# UNITED STATES PATENT AND TRADEMARK OFFICE

| APPLICATION NO.   | FILING DATE | FIRST NAMED INVENTOR | ATTORNEY DOCKET NO. | CONFIRMATION NO. |
|---|-------------|----------------------|---------------------|------------------|
| 10/532,402  | 04/22/2005  | Marko Siebert        | BM-168PCT           | 9126             |

**Office Action Summary**

Annotated Fig. 5 (U.S. Pat. 5,679,419)

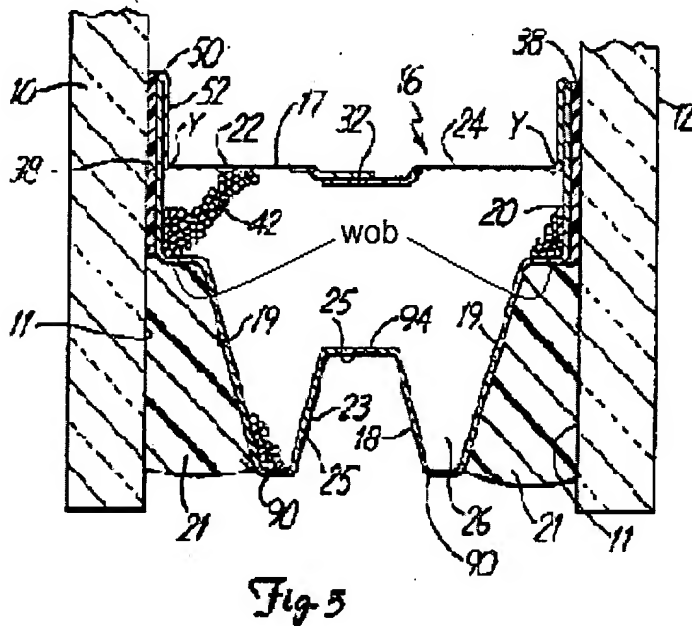
**Claim 1** is rejected under 35 U.S.C. 103(a) as being unpatentable over Larsen in view of Fratti et al.

Larsen discloses a spacer (S) comprising a generally rectangular open space (Larsen comprises a generally rectangular open space as broadly recited) filled with moisture-absorbing material (42); said open space bounded by side walls (20), a rear wall (94), and an inner wall (17); said spacer rear wall having two webs (19) inclined towards each other and projecting from the rear wall in the direction opposite the open space, the space created between the webs and the panes capable of being filled with sealant (21); and the two portions of the wall (wob) outside the bounds of the two webs lying on a different plane (lower or otherwise) than the portion of the wall (25) inside said bounds.

Larsen does not disclose parallel webs.

Fratti et al. discloses a spacer (120) having parallel webs (122).

It would have been obvious to one of ordinary skill in the art at the time the present invention was made to include the parallel webs as in Fratti et al. in the structure of Larsen to provide a uniform sealant thickness.

Annotated Fig. 12 (German reference 2,224,264)

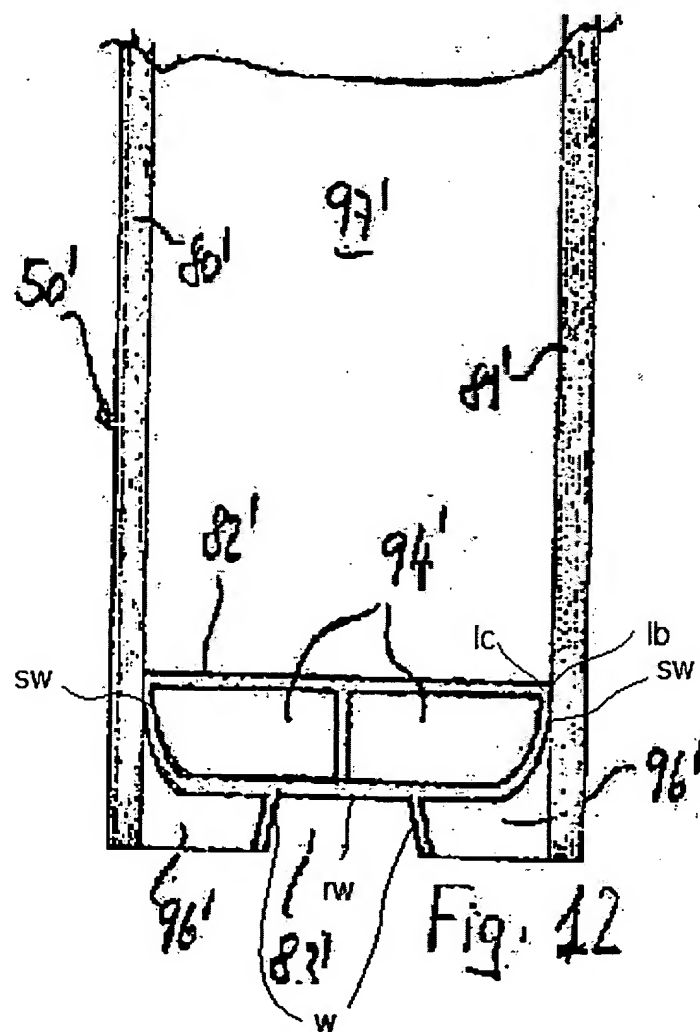
**Claim 6** is rejected under 35 U.S.C. 103(a) as being unpatentable over Larsen in view of German reference 2,224,264.

Larsen discloses all the claimed limitations as described above. Larsen does not disclose the lower corner of the side wall forming a lower boundary of the sealant space.

German reference 2,224,264 discloses a spacer having webs (w) wherein the lower corner (lc) of the side wall (sw) forms a lower boundary (lb) of a sealant space (96').
